# MEMORANDUM

Re: Bishop Place Planned Development Approval Time Extension Request

# Staff Report

To: Salt Lake City Planning Commission  
From: Daniel Echeverria, 801-535-7165, Daniel.echeverria@slcgov.com  
Date: June 18, 2014  
Re: PLNPCM2014-00021 432 N 300 West Zoning Amendment; PLNSUB2014-00019/00020 Bishop Place Planned Development and Subdivision

SHEET NO.  
**C1**

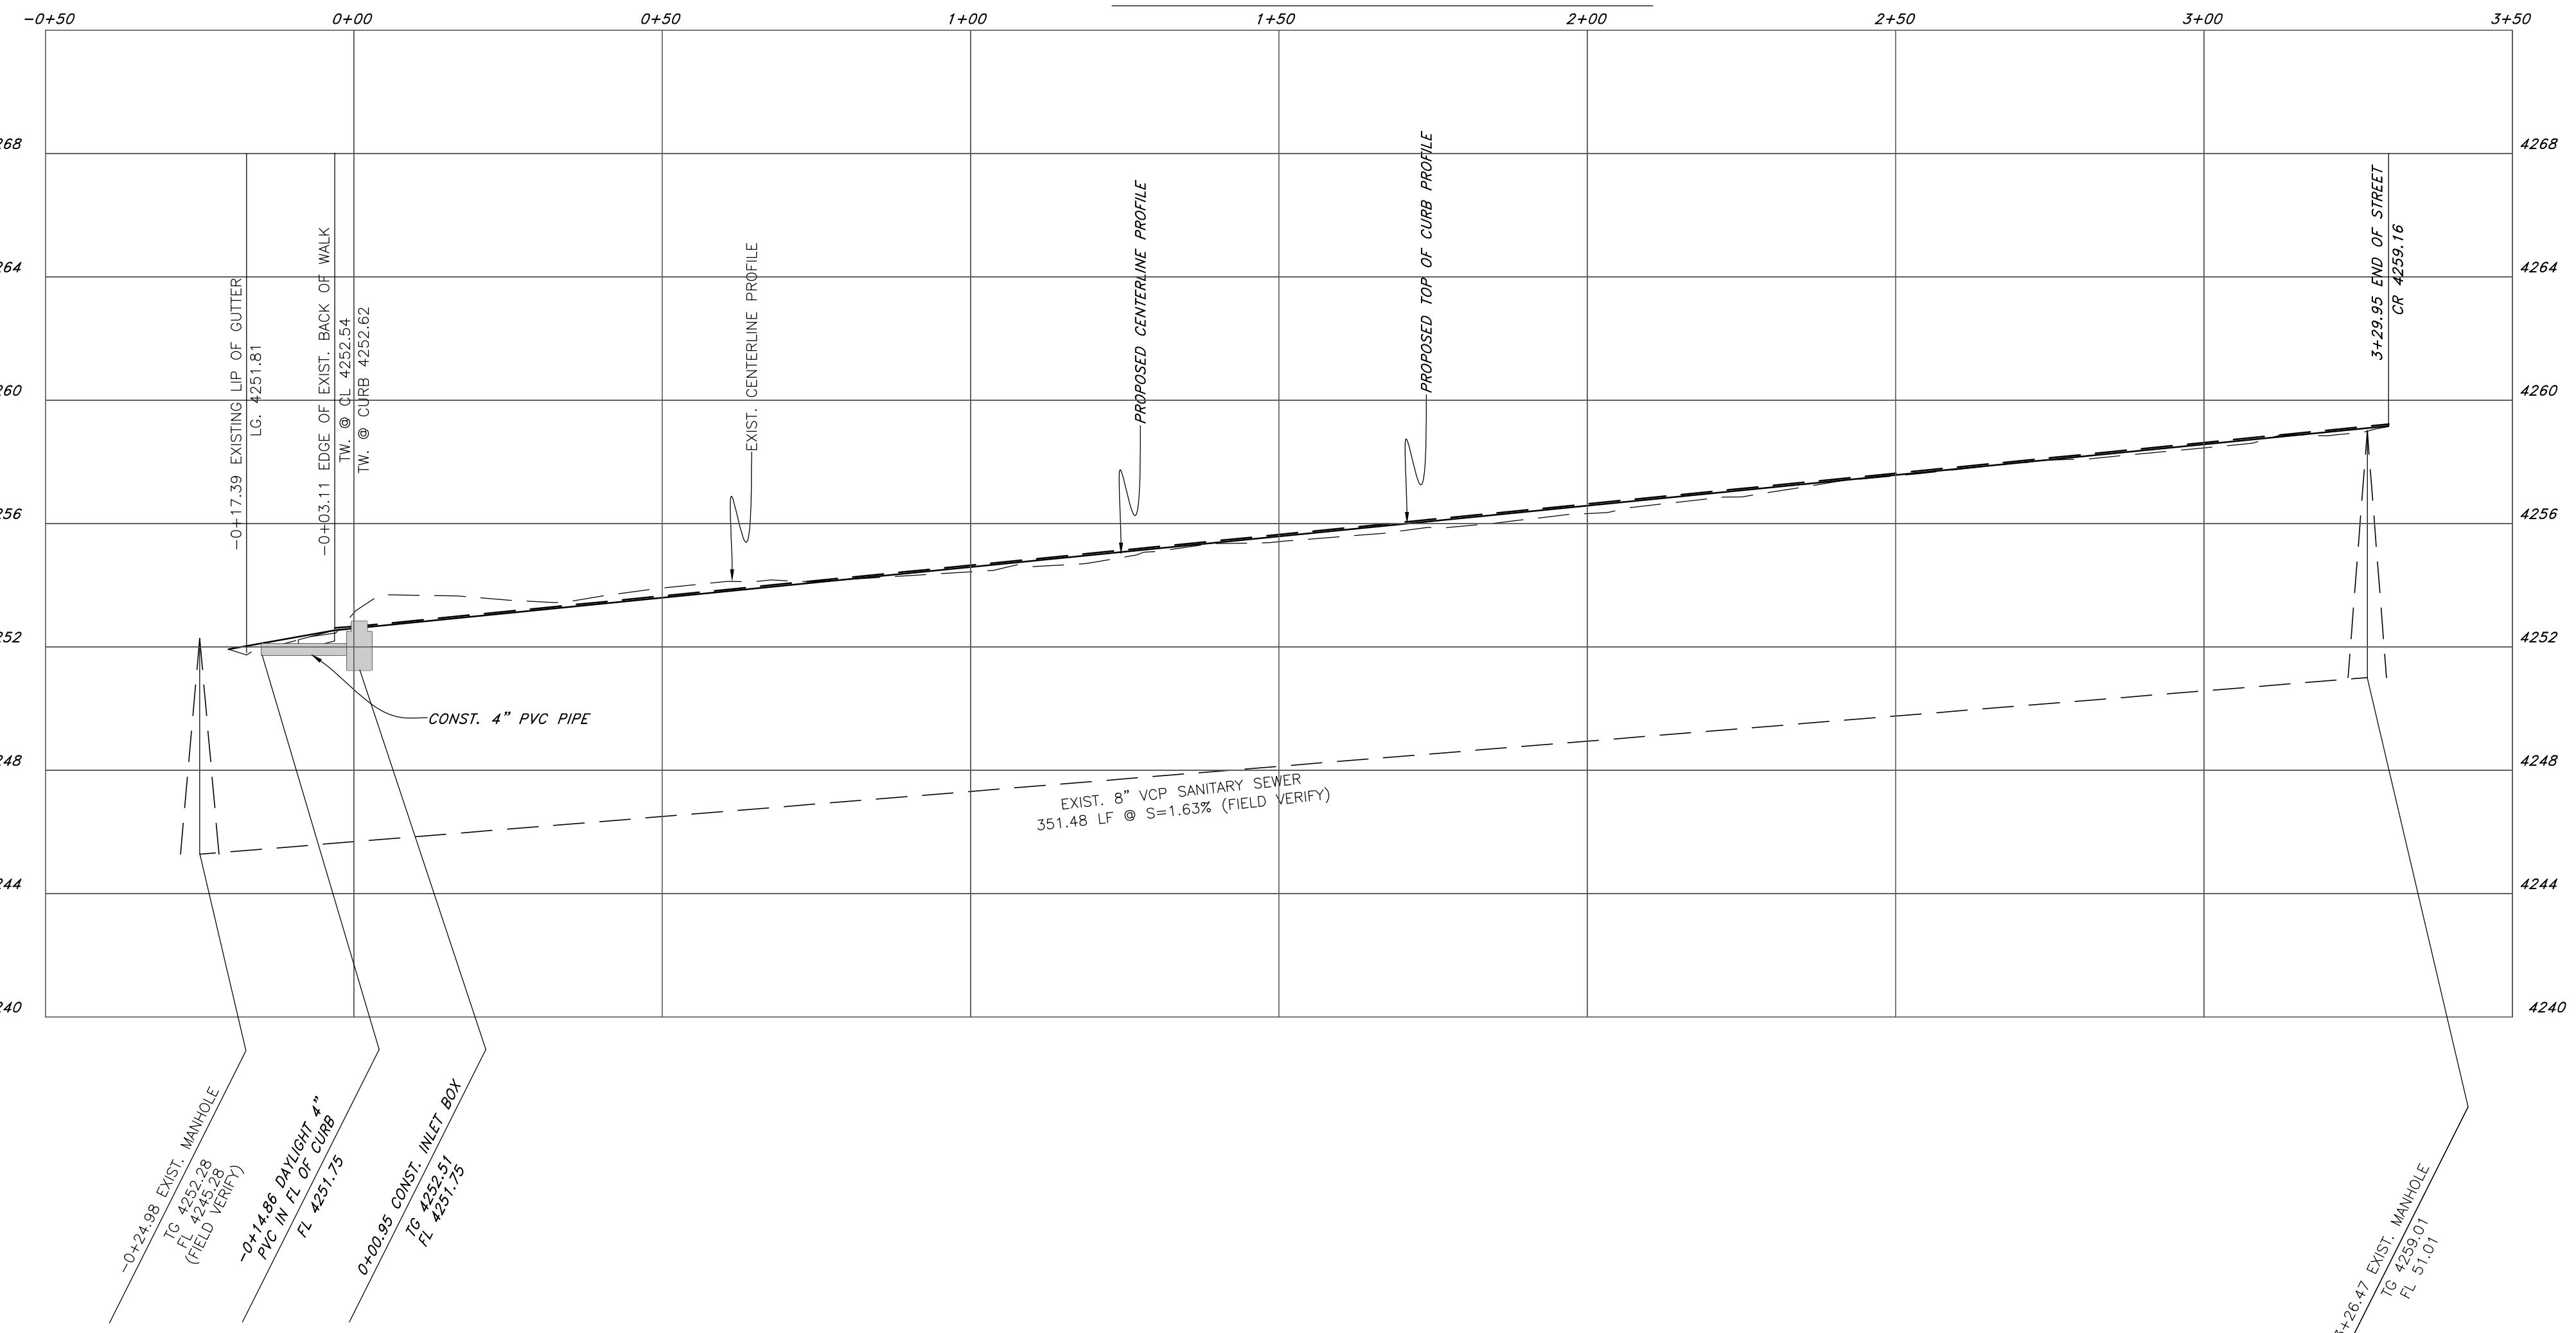
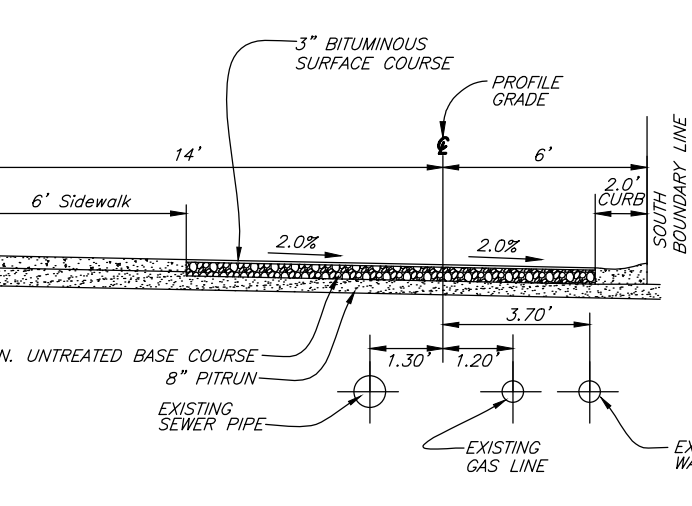
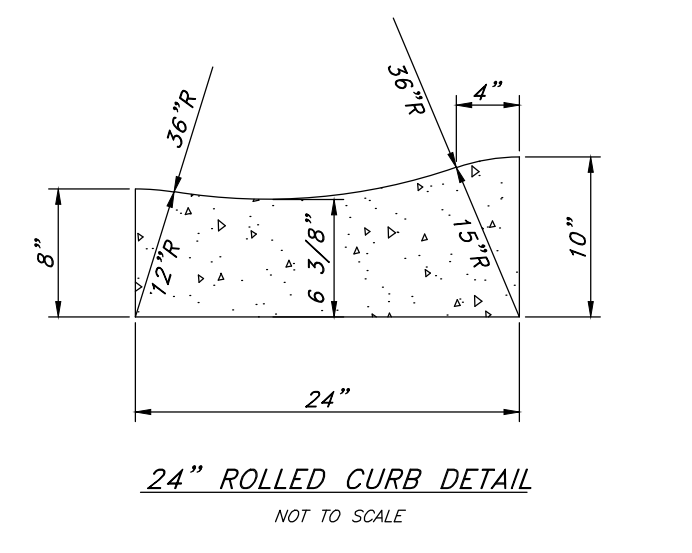
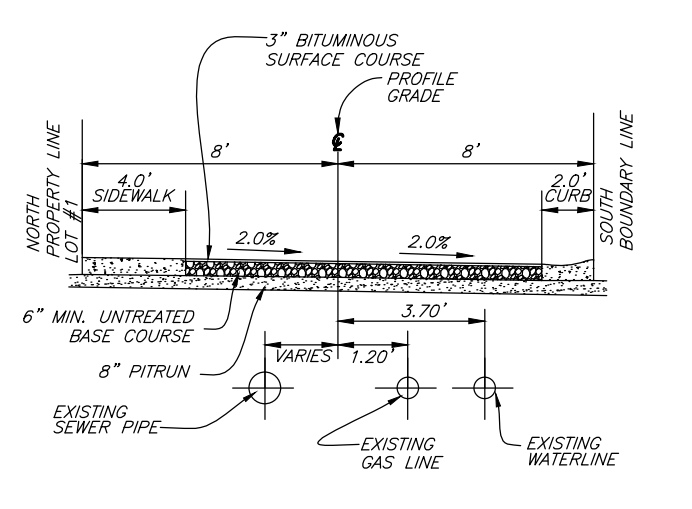
Normally, the street would need to be at least 20' in width and have a fire vehicle turnaround to meet Fire Code standards. However, 20' of width is not available for the entirety of the street and so the normal Fire standard cannot be met. Due to this limitation, the applicant is proposing to provide fire protection with fire sprinkler systems for all homes to the east of the 18' wide portion of the street. The Fire department accepted the proposal and is modifying the requirement for a full size emergency vehicle turnaround and 20' of street width on the condition that fire sprinklers are installed in these homes and that the sprinklers are inspected annually.

The proposed street was reviewed by the Streets department, which is responsible for snow removal. The Streets department indicated that although a "T" type turnaround at the end of the street would be preferred, their smallest snow removal vehicles can turnaround within a 20' street width. They note that if there is just one car parked on the street, snow removal would not be possible. In response to the turnaround recommendation, the developer is proposing a semi-circular turnaround at the end of the street with a width of 37' at the widest point to accommodate the turnaround of snow removal and other larger vehicles. This reduces the potential for property damage from vehicles to the homes that directly abut the street.

Here is our input on this subject after the recent proposed modifications. As far as hauling snow goes we only provide that service in extreme conditions and typically from down town only. The normal operational approach is to let warmer temperatures melt it away and that way we do not have to load and unload sanders and burn extra fuel. Based on Michael's experience 20 feet is adequate to turn around our smallest snow removal vehicle (F550) that we have to use on this location. You questioned backing in or out of this section. It is a safety item for us. Under possible dark icy conditions we rather not have to back our vehicles whenever possible. One important point is that even though there would be no parking allowed anywhere on this street even if there is one car parked there we would not be able to provide snow services.

The issues with turning around would be better resolved if the street had a "T" at the end. There are a couple of streets like this in the city and it works. The only other issue I can think of from my perspective is who is going to remove the snow that piles up at the end of the street? We typically do not have a free truck in the winter to haul snow away. If we unload a trucks to haul salt or snow, we could possibly do it then. 20' would be adequate to turn a F-550 around too.

It is extremely narrow where you enter off of 300 West. The turn is extremely tight and is on a (busy at times) roadway. There is an existing business on the south side where Bishop Place starts that is right up against the road. There is no buffer to avoid hitting the building, and this seems to be the most narrow part of the street. There may be room to widen this portion if the large trees on the north side are removed. There is really nowhere to push the snow on either side, not even a sidewalk right now, however I would think some sort of walkway is planned. There needs to be an area at the East end to turn around. At this time it is a very blunt "Dead End" street. In order to plow it, we would have to back down or back out. Both of these options would have us backing and stopping on 300 West which can be very dangerous. As it sits now, the service level will be provided by a F-550, and I see no way that another form of snow removal would ever be possible. My final observance is that if parking is allowed on this street during storms, plowing may be rendered impossible.

The police department has had significant problems regarding parking/property issues in neighborhoods with narrow "streets" such as this. Additionally, emergency response by the Fire Department can sometimes be delayed or blocked. An example of this type of area would be Laxon Ct. If the developer can include sufficient parking so that the street remains open for travel that would mitigate our concerns.

***Planning Staff Note:*** *In reponse to these comments, the applicant is installing a 37' wide turnaround on the street to accommodate snow removal vehicle turnaround.*

*Planning Staff Note: The applicant submitted an Alternative Means and Methods application to the Fire Department. The applicant requested approval of the proposed street on the condition that fire sprinklers are installed in all of the buildings on Bishop Place.*

1. The fire sprinkler systems is NFPA 13D with modifications
2. The fire sprinkler system it to receive annual inspections and maintained operational.
3. The sprinkler system shall be provided with tamper switches, and flow switch that is interconnected to an approved remote monitoring company.
